**REQUEST FOR SECRETARY'S ENVIRONMENTAL ASSESSMENT REQUIREMENTS
BAPTIST CARE REDEVELOPMENT
157 BALACLAVA ROAD, MACQUARIE PARK**

Subject: Request for Secretary's Environmental Assessment Requirements (SEARs) for BaptistCare Macquarie Park Masterplan SSD-46561712

157 Balaclava Road Macquarie Park - Request for SEARs - BaptistCare Macquarie Park Masterplan –

Project: Concept State Significant Development Application (Masterplan) SSD 46561712

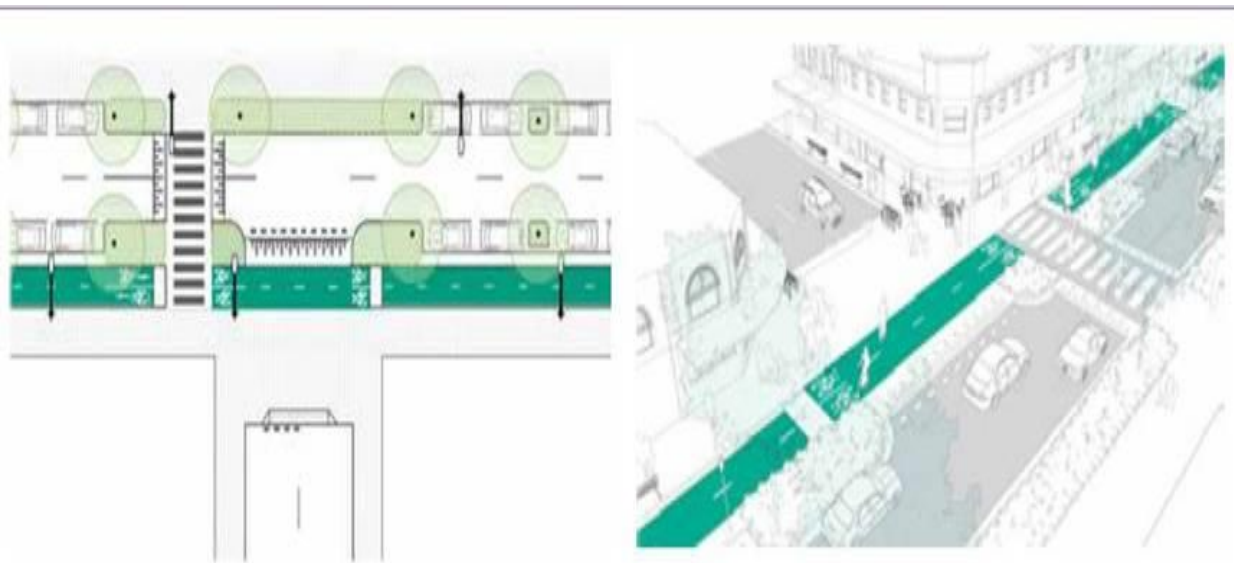
A new road with a 20m road reserve width is to be delivered on the north-east boundary of the site and is to connect Balaclava Road to the future Road 3 through the neighbouring property of 122 Herring Road, Macquarie Park, refer below sketch.

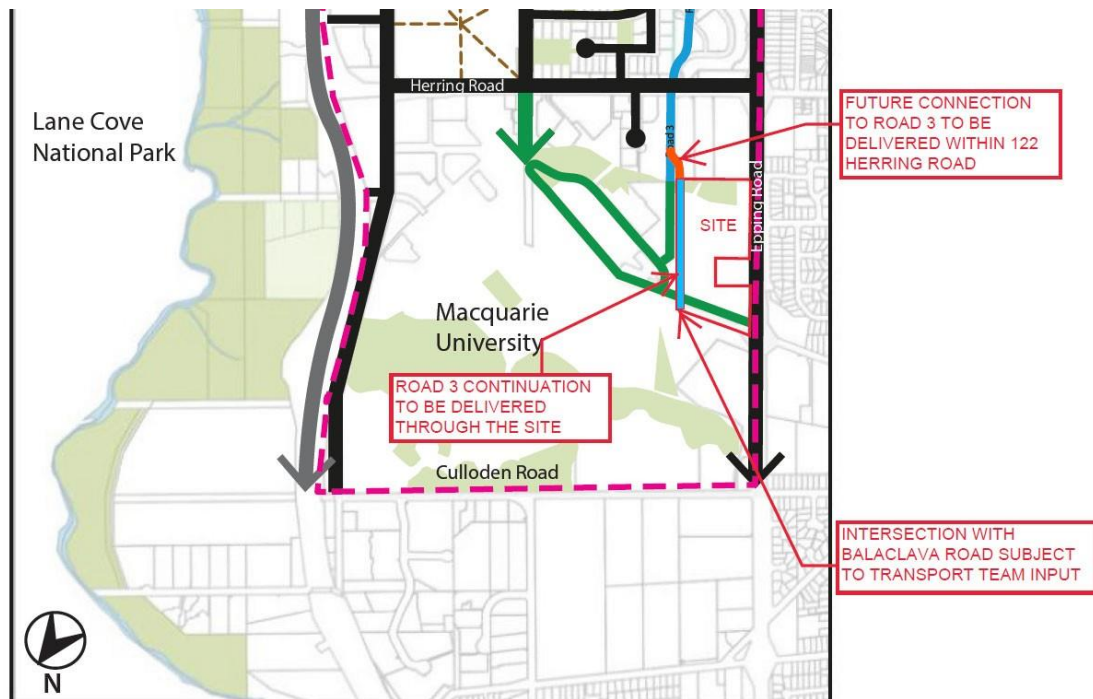
Council will require a staging plan showing the extent of public domain works proposed with each stage of the development. The staging plan should carefully consider the following:

- How to maintain ongoing pedestrian and traffic flow along the frontage during each phase and interim periods.
- How to maintain pedestrian and vehicular access from the public road reserve into each active part of the site (construction or occupation) during each phase and interim periods.
- How to maintain necessary access for emergency services and utility authorities during each phase and interim periods.
- How will transition from new to existing infrastructure within the public domain be treated, particularly in cases where there are significant level differences – eg. Boundary footway levels. The above plan and accompanying information would be required as part of the submission documents for the concept stage application.

Balaclava Road Bus-stop

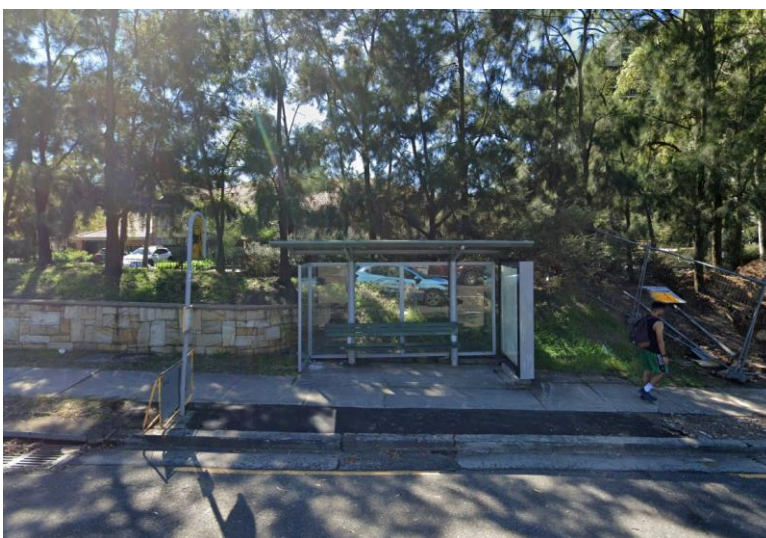
Any bus stops located along the frontages of the site must be replaced and upgraded to meet Council's current bus shelter standards – currently Evo Premium bus shelter. The bus stop must comply with all requirements of the Disability Discrimination Act (DDA), including but not limited to aspects such as tactile for the vision impaired, minimum grades to facilitate disabled access including wheelchair maneuvering. Currently there are three existing bus stops with shelters located on the Balaclava Road and Epping Road frontages of the development site. Arrangement will need to be made with Sydney buses and any other relevant authorities to arrange for temporary relocation of the bus stop during public domain works.
